STATE OF HAWAII DEPARTMENT OF TRANSPORTATION HIGHWAYS DIVISION	
GABION WALL AND APRON DETAIL	
CASTLE HILLS ACCESS ROAD Drainage Improvements, Phase 2 FEDERAL-AID PROJECT NO. STP-0300(125)	
Scale: As Shown	Date: December 2011
SHEET No. C5.1 OF C5.4 SHEETS

ADD. 17

CASTLE HILLS ACCESS ROAD
Drainage Improvements, Phase 2
Federal-Aid Project No. STP-0300(125)

BAFFLES DETAIL 1
Scale: 1/2" = 1'-0" S2.3 | S2.3

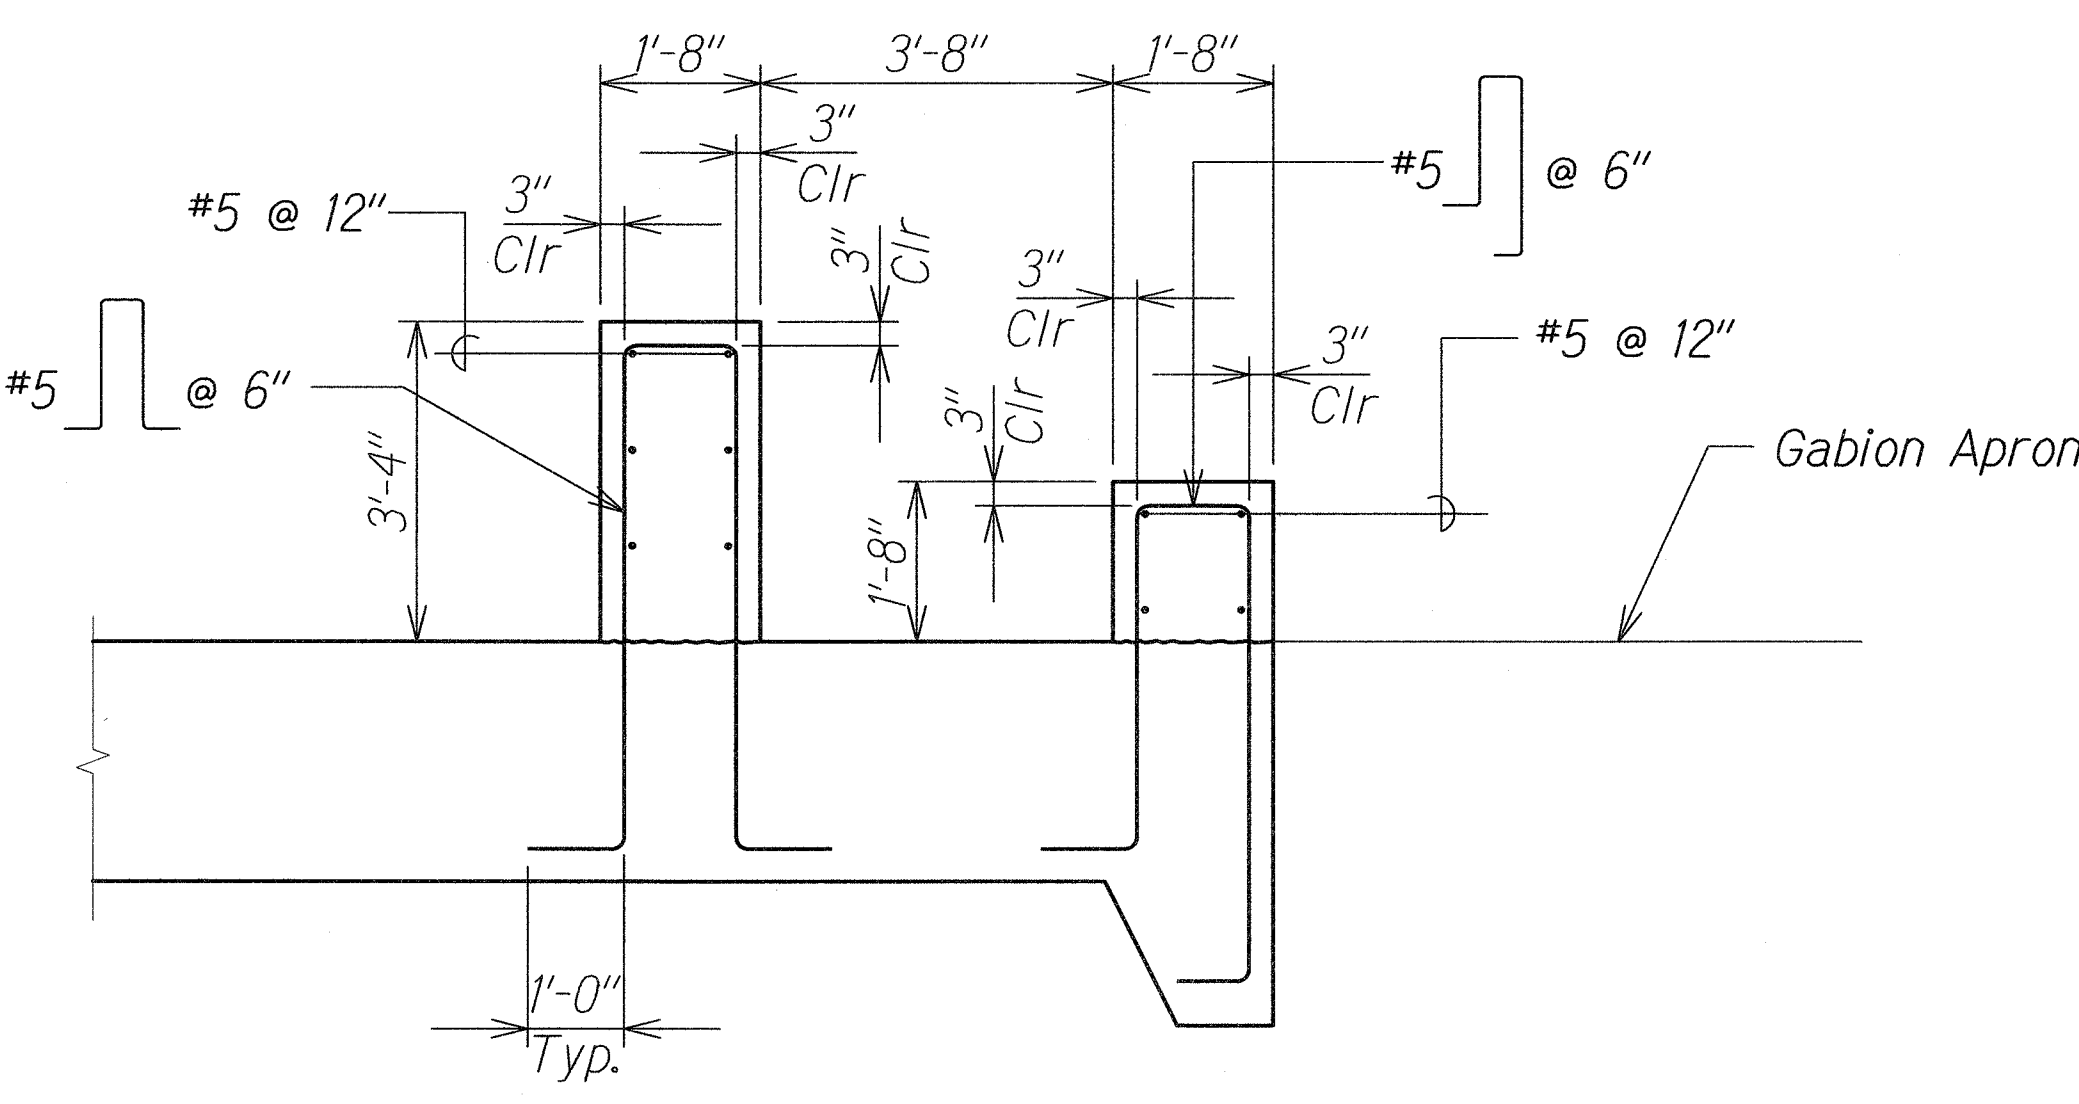
01/19/12	1 Note Clarification.
DATE	REVISION

MICROPILE DETAILS AND NOTES

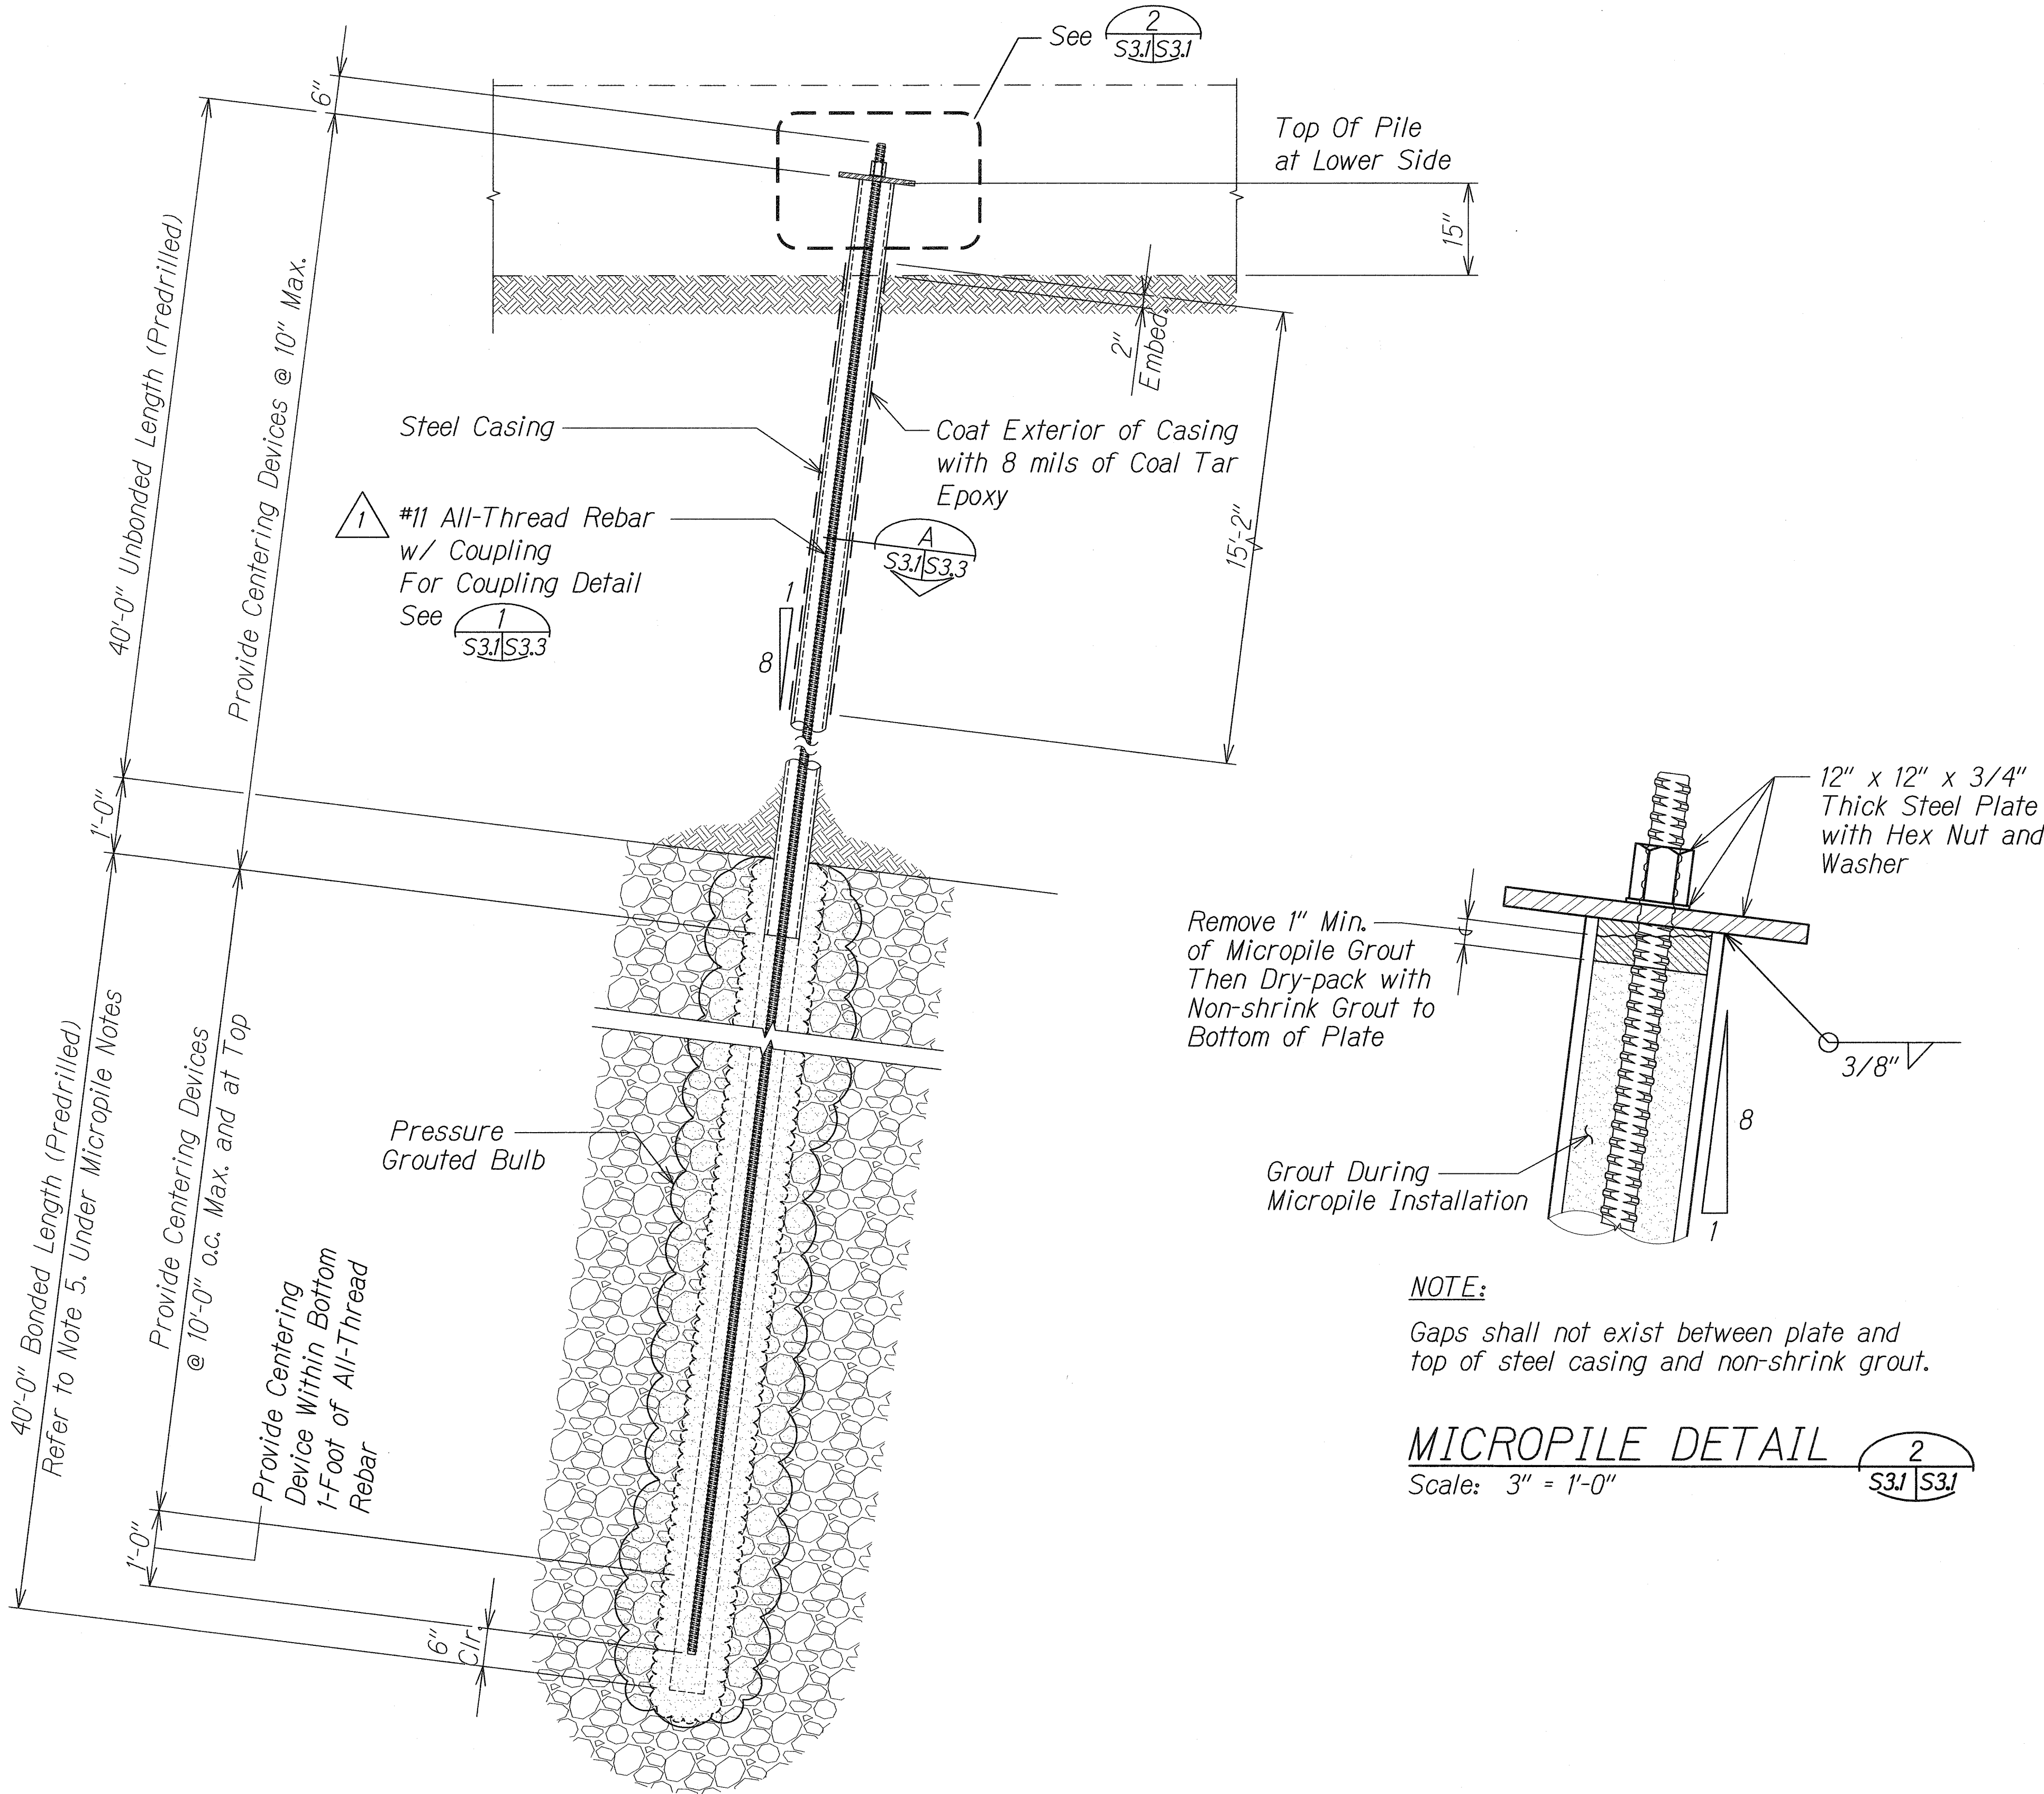
01/19/12	1	Revised Bar Size. Revised Demand Loads.
DATE	REVISION

Micropile Load Combination (Demand)			1
	Axial Load (kips)	Moment (k-ft)	
Strength Limit State	80 Compression	30	1
Strength Limit State	30 Tension	30	1

TYPICAL PREPRODUCTION MICROPILE DETAIL
 Scale: 3/4" = 1'-0"
 S3.2 S3.2

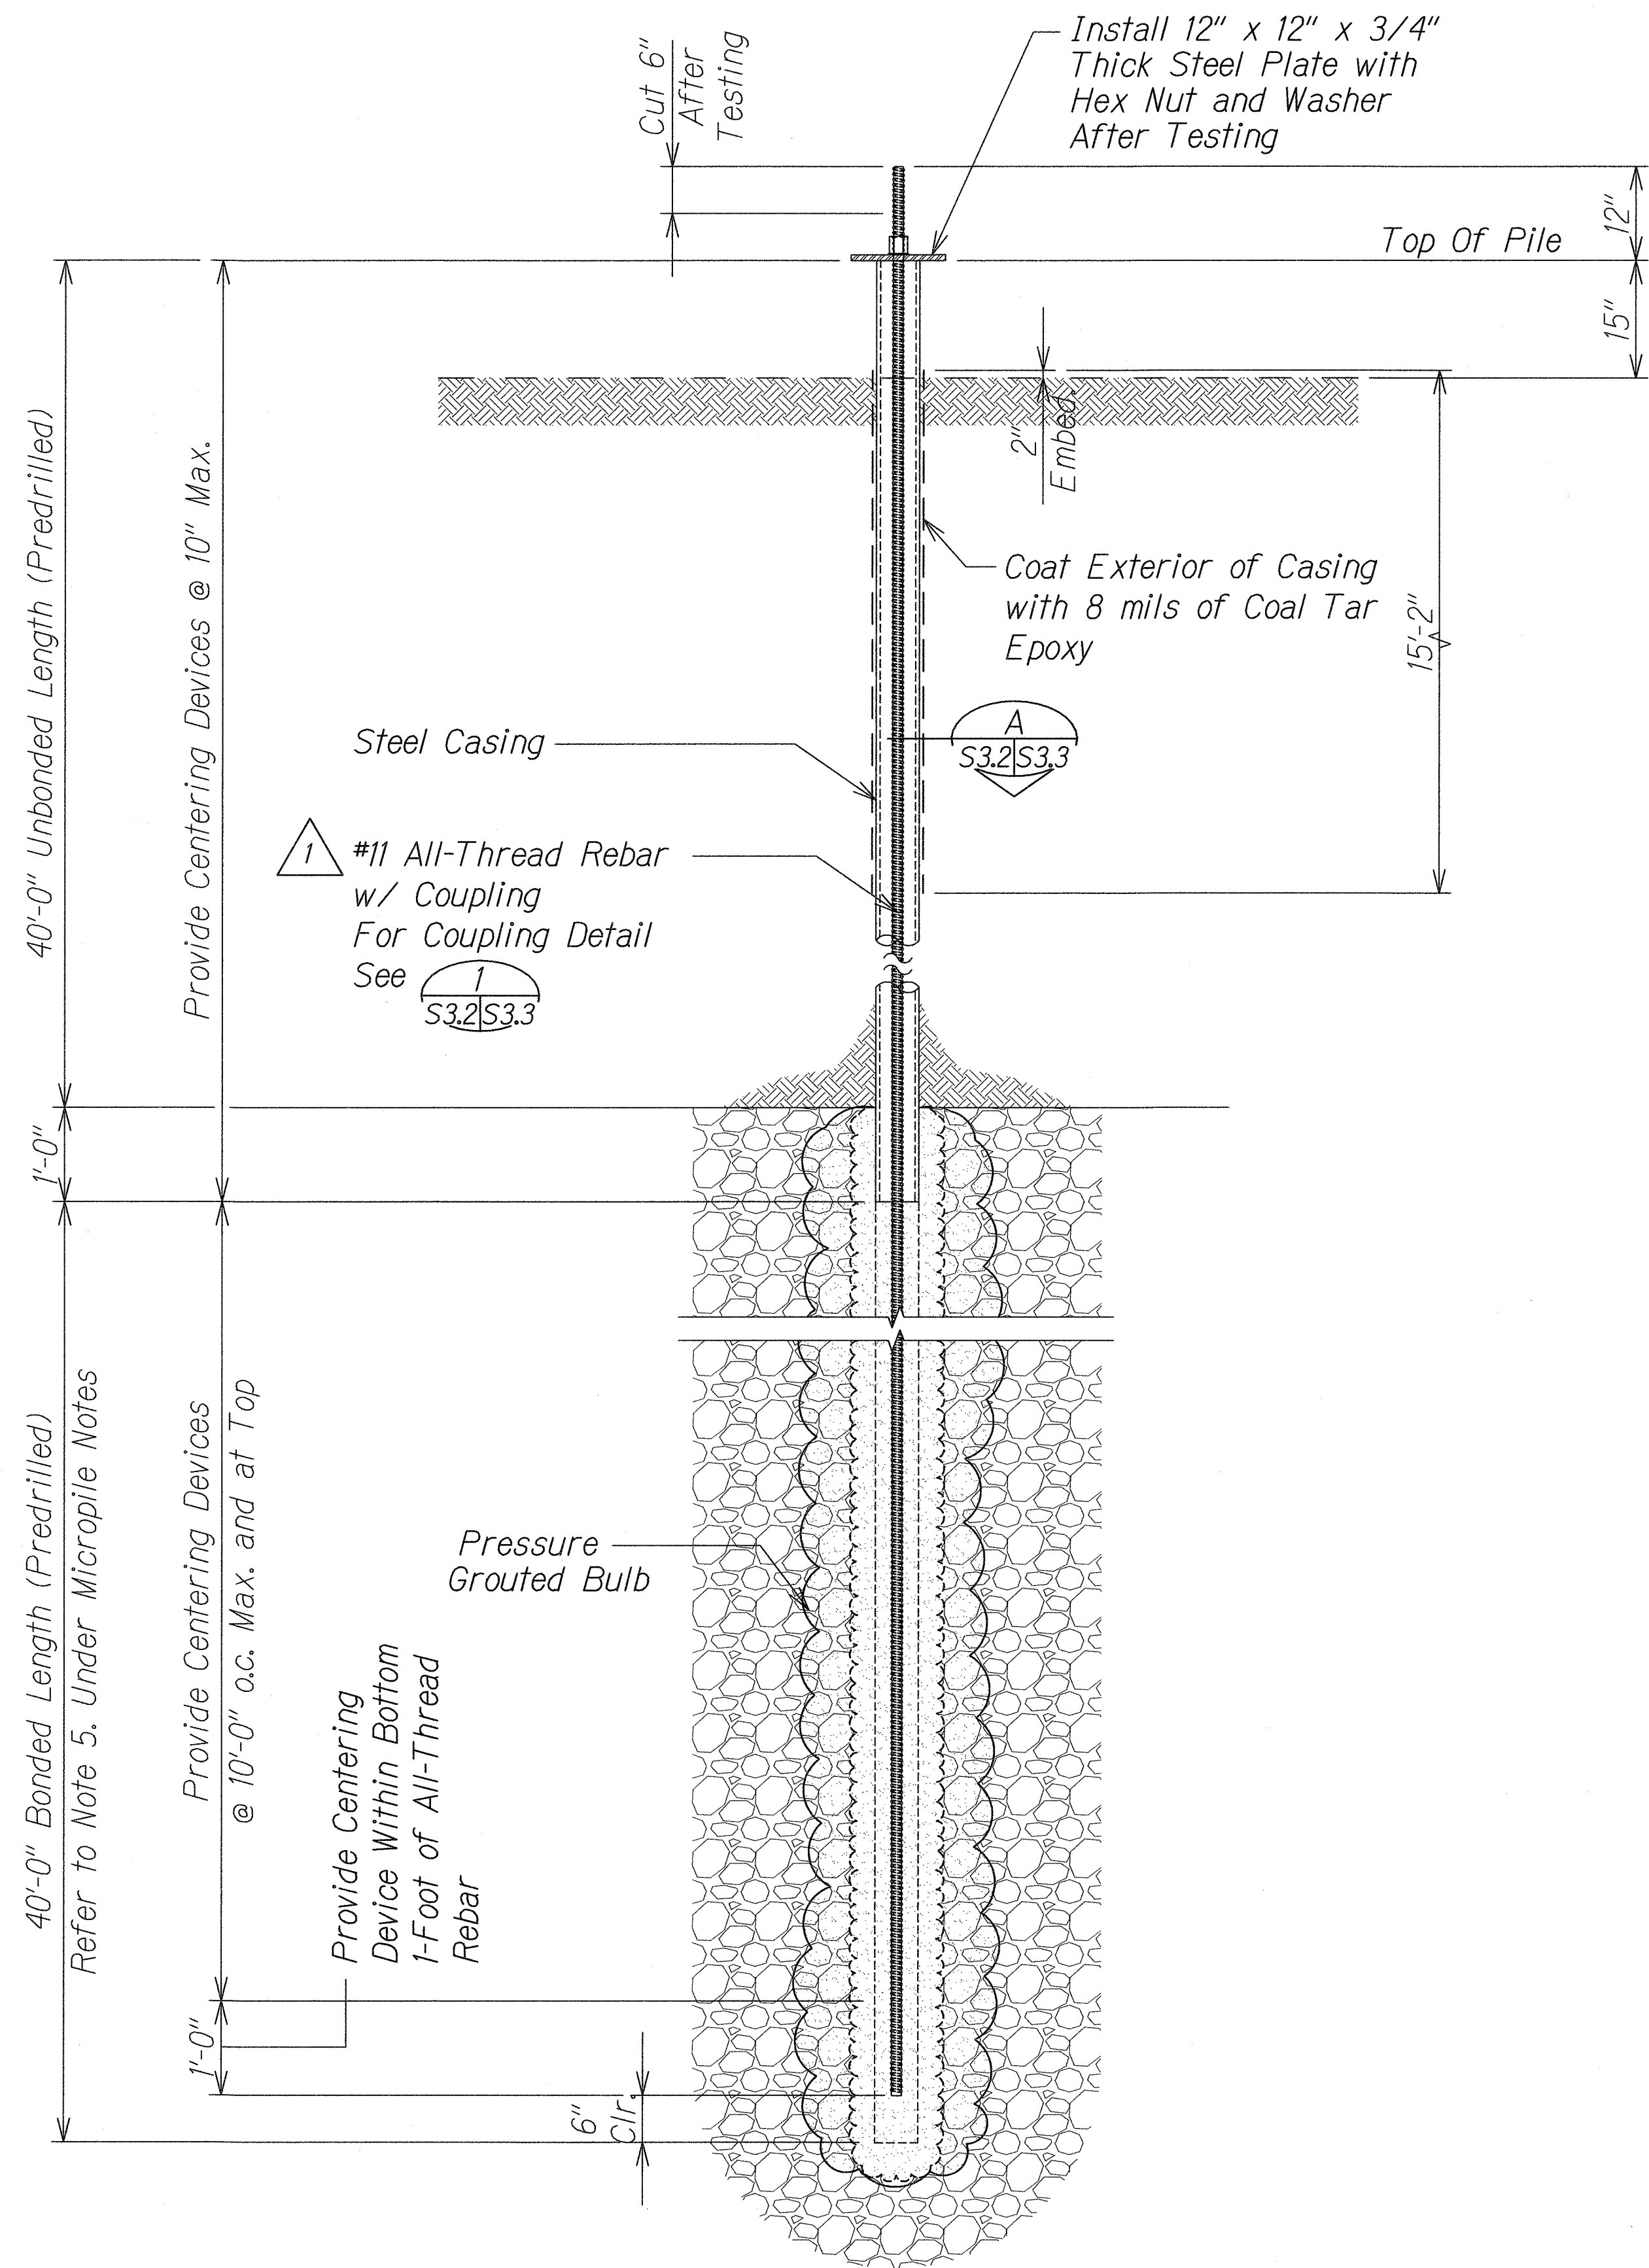
01/19/12	1 Revised Bar Size.
DATE	REVISION

MICROPILE DETAIL AND SECTION

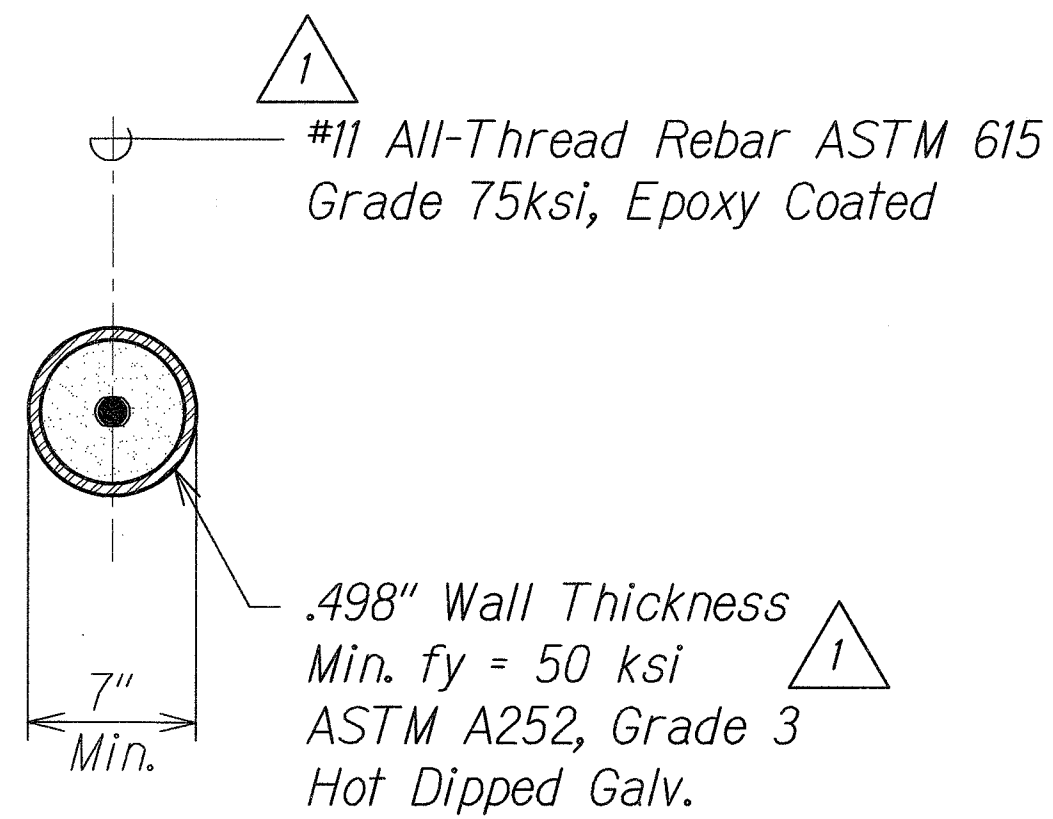
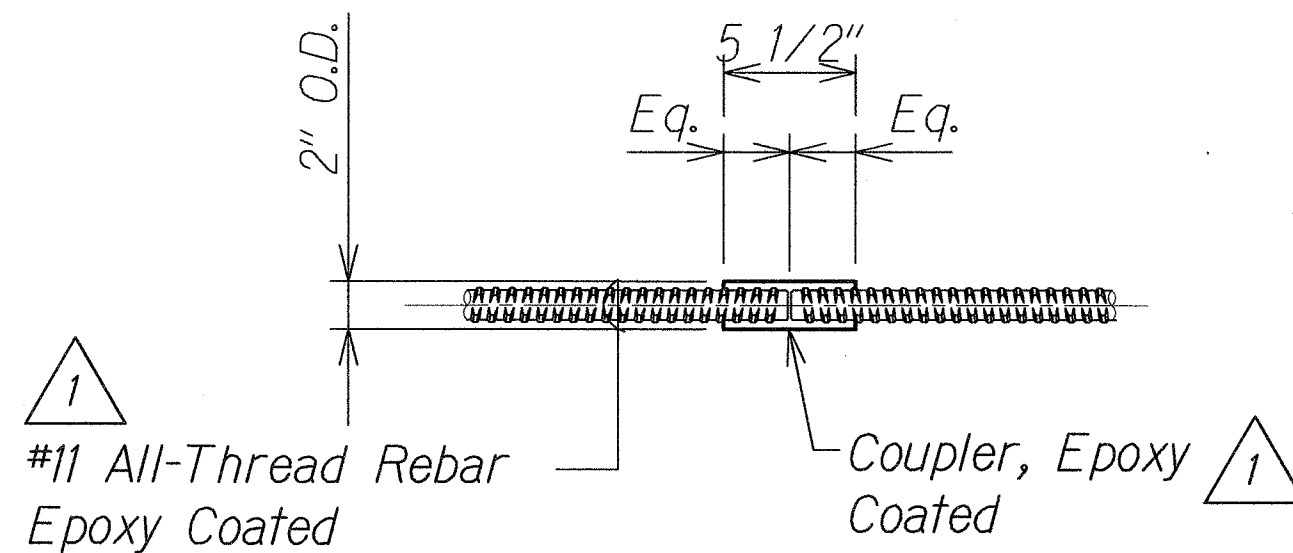
Revised Bar Size. Revised Casing
Properties. Revised Coupler
Properties.
